UNITED STATES
NUCLEAR REGULATORY COMMISSION
WASHINGTON, D. C. 20555

SUBJECT: DRAFT SUMMARY OF ATWS VALUE-IMPACT ANALYSES

Enclosure:
Draft Summary Value-Impact Analysis

2.1 ATWS Safety Objective

FIGURE 6-1 Frequency of Man-Caused Events Involving Fatalities.

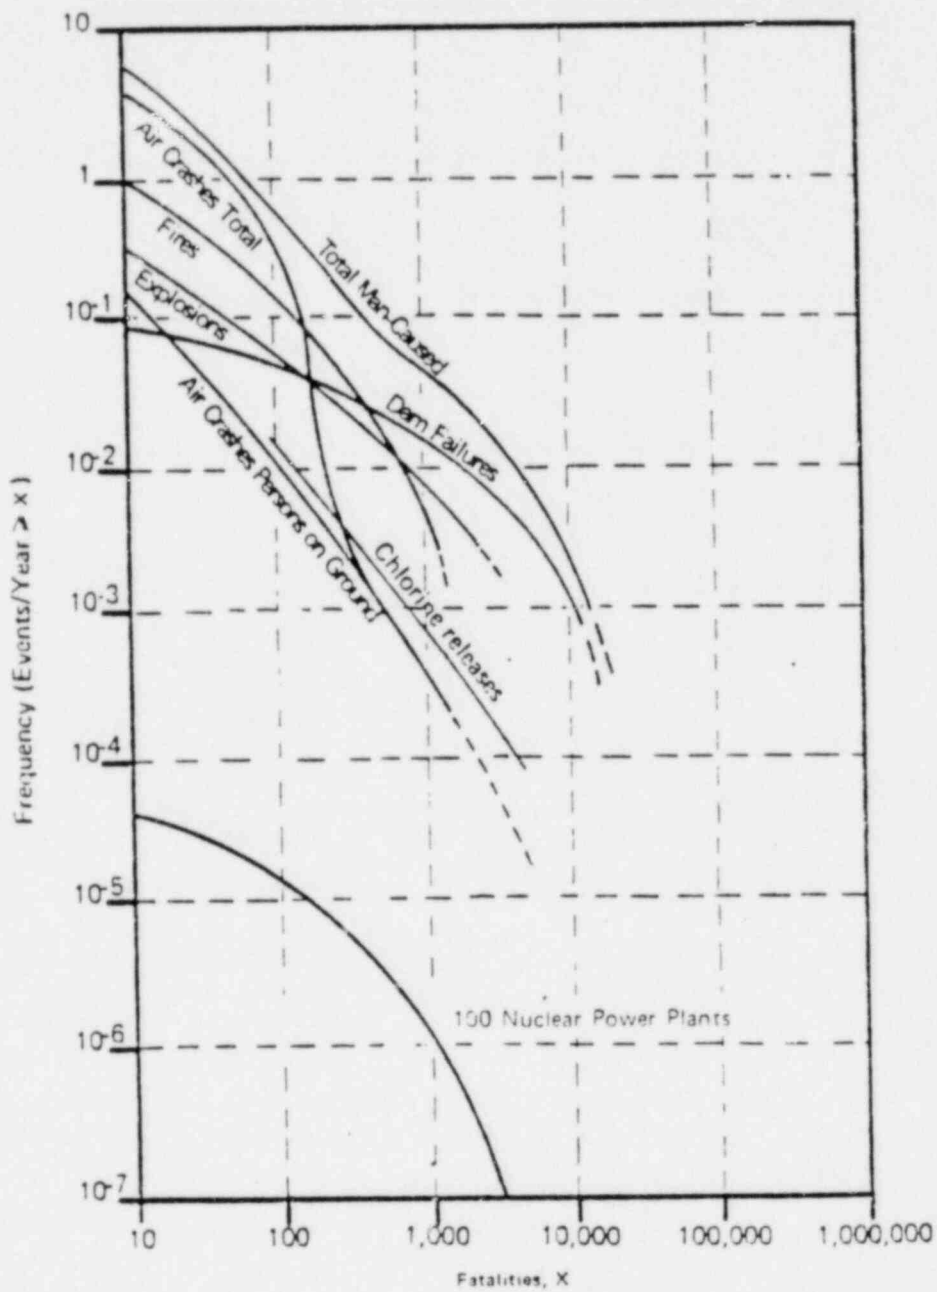
But we know that ATWS are mostly handled in RSS
